World Forum for Harmonization of Vehicle Regulations**Working Party on Lighting and Light-Signalling****Eighty-ninth session**

Other UN Regulations**Proposal for Supplement [13] to the 01 series of amendments
to UN Regulation No. 45****Submitted by the experts from the International Automotive Lighting
and Light-Signalling Expert Group ***

Diagram of Measuring Points on a Screen

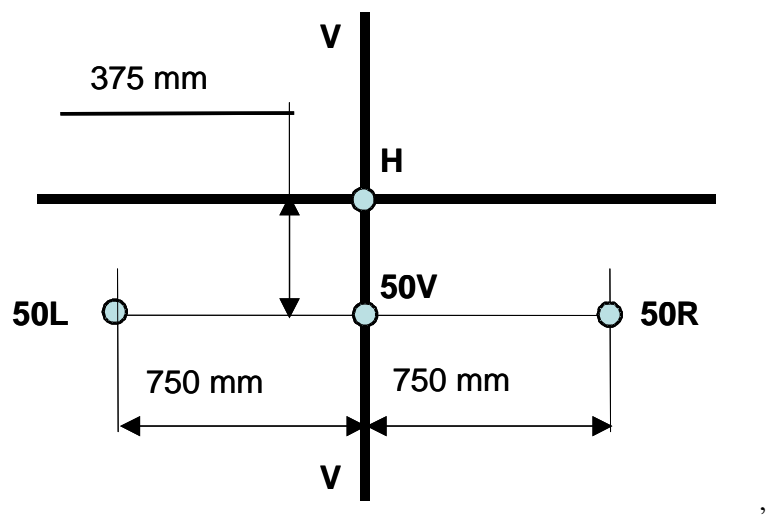
- “7.1. The efficiency of the cleaner shall be tested in accordance with the requirements of Annex 4 to this Regulation. The cleaning efficiency at the points on the measuring screen which are specified below shall, after every cleaning period, amount to at least 70 per cent for the principal passing beam lamp and also 70 per cent for the optional driving lamp; in case of an AFS this provision applies to the photometric test procedures as defined in Annex 9 to UN Regulation No. 123 or in Annex 4 to UN Regulation No. 149 from those lighting units in the neutral state indicated in paragraph 6.1.1. above. In the case of a headlamp (UN Regulations Nos. 98, or 112 or classes A, B or D of UN Regulation No. 149) providing bend lighting, the headlamp shall be set for the test in a straightforward direction.
